MUTUALS ON FRONT PANEL

PX-9-119

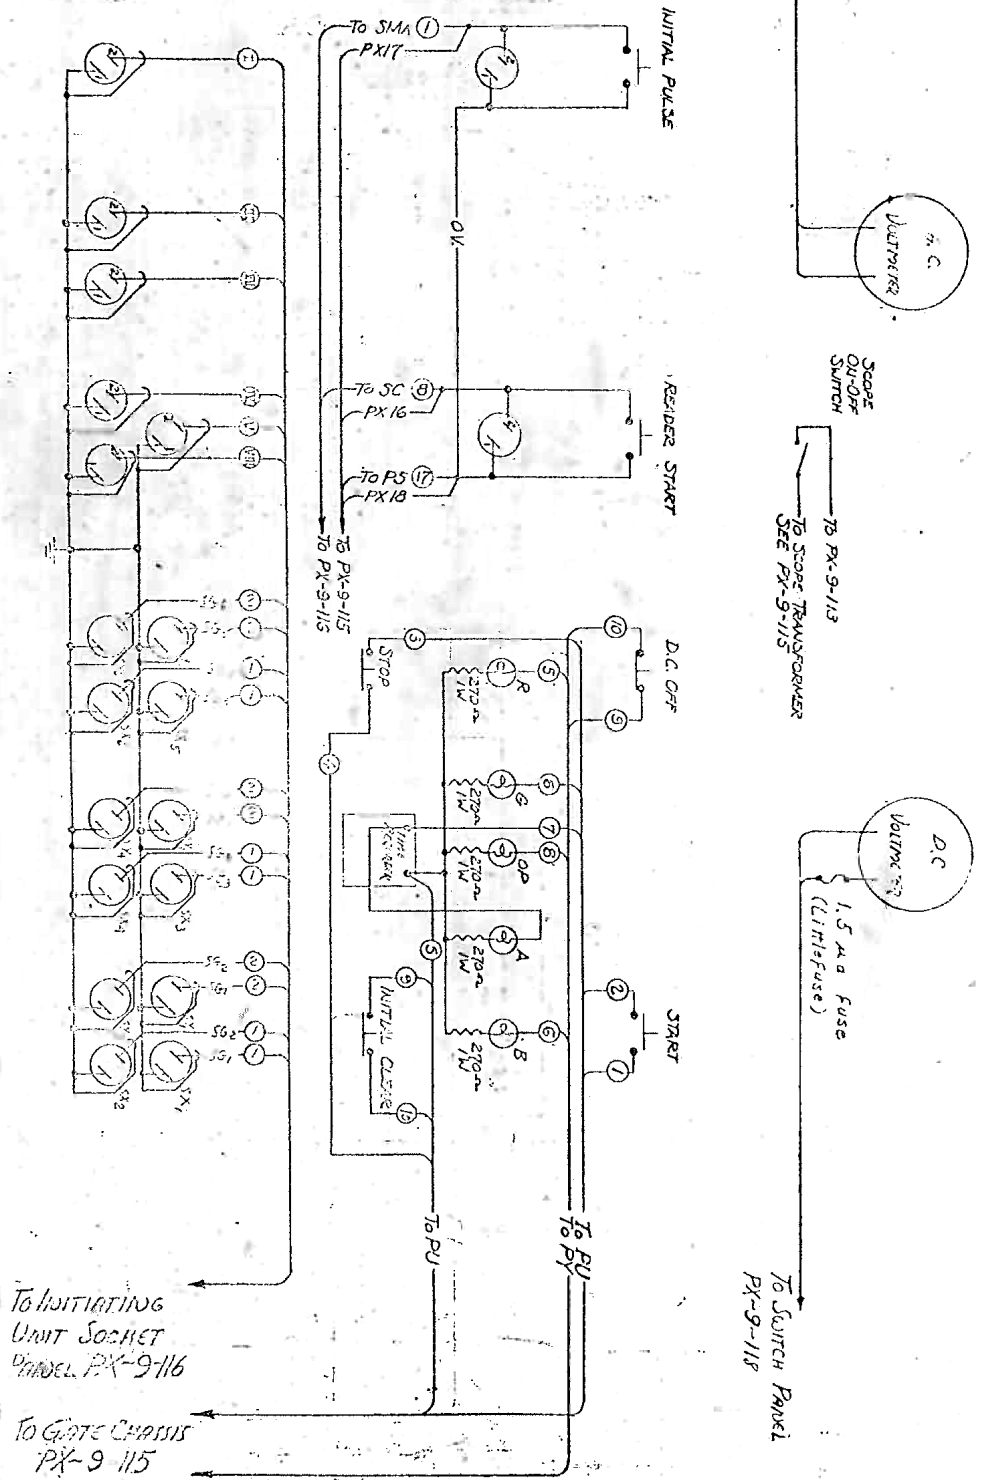
INITIAL CDR. CHANGED.
270 OHM RESISTORS
& 1.5 A FUSE ADDED.

SCOPE SWITCH ADDED.
B, O, R, K PILOT LIGHTS ADDED.
DOOR SWITCH SHUNT SWITCH
REMOVED.
D.C. OFF SWITCH ADDED
